APPLICATION NO.	FILING DATE	FIRST NAMED INVENTOR	ATTORNEY DOCKET NO.	CONFIRMATION NO.
10/761,812	01/20/2004	Brent Hauck	DUR-120	2286

Office Action Summary

This is the first office action for application number 10/761,812, Seat Track Assembly and Method of Manufacture, filed on January 20, 2004.

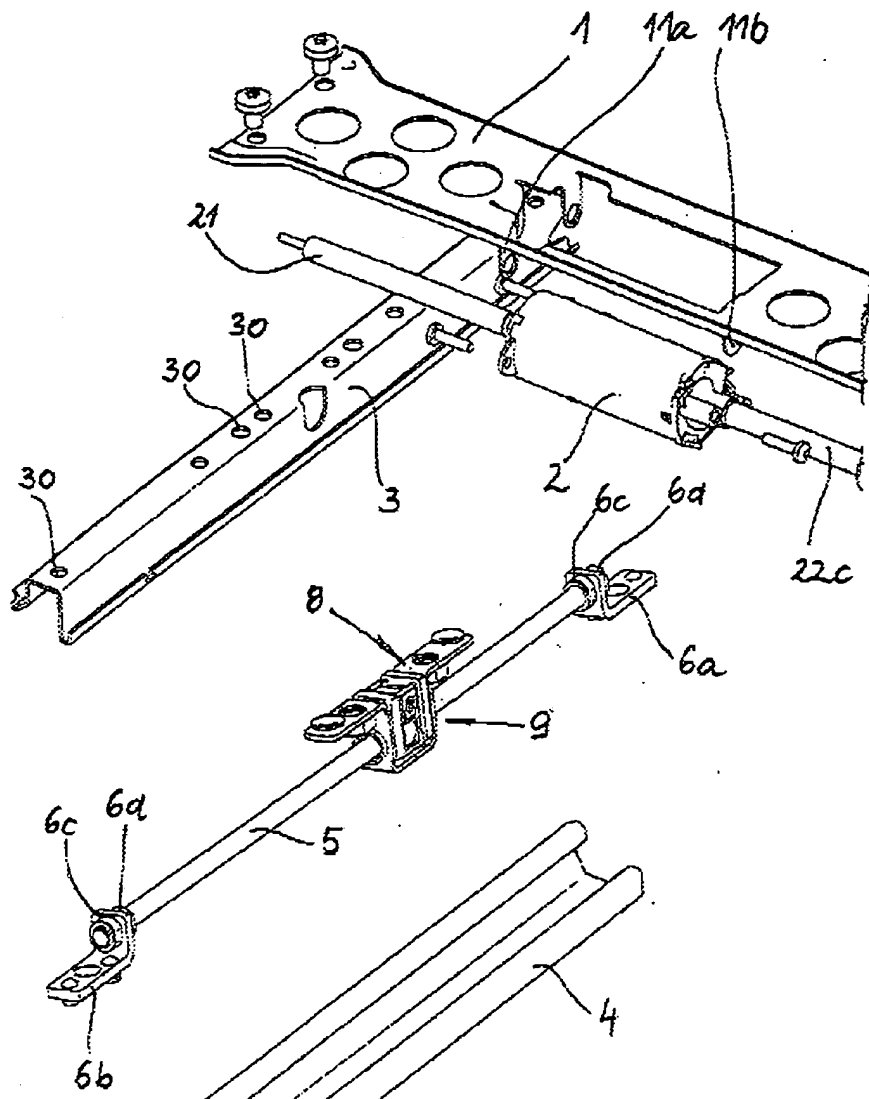
The drawings are objected to under 37 CFR 1.83(a) because they fail to show "angled portion 56" as described in the specification on line 15 of page 6. Further, line 16 of page 6 recites "an angled portion 58 of each sidewall of the lower track 20..." However, in figure 3, reference numeral 58 is directed towards a portion of the upper track. Further, the previously recited passage recites "lower track 20" and should be --lower track 24--. Any structural detail that is essential for a proper understanding of the disclosed invention should be shown in the drawing. MPEP § 608.02(d). Corrected drawing sheets in compliance with 37 CFR 1.121(d) are required in

reply to the Office action to avoid abandonment of the application. Any amended replacement drawing sheet should include all of the figures appearing on the immediate prior version of the sheet, even if only one figure is being amended. The figure or figure number of an amended drawing should not be labeled as "amended." If a drawing figure is to be canceled, the appropriate figure must be removed from the replacement sheet, and where necessary, the remaining figures must be renumbered and appropriate changes made to the brief description of the several views of the drawings for consistency. Additional replacement sheets may be necessary to show the renumbering of the remaining figures. Each drawing sheet submitted after the filing date of an application must be labeled in the top margin as either "Replacement Sheet" or "New Sheet" pursuant to 37 CFR 1.121(d). If the changes are not accepted by the examiner, the applicant will be notified and informed of any required corrective action in the next Office action. The objection to the drawings will not be held in abeyance.
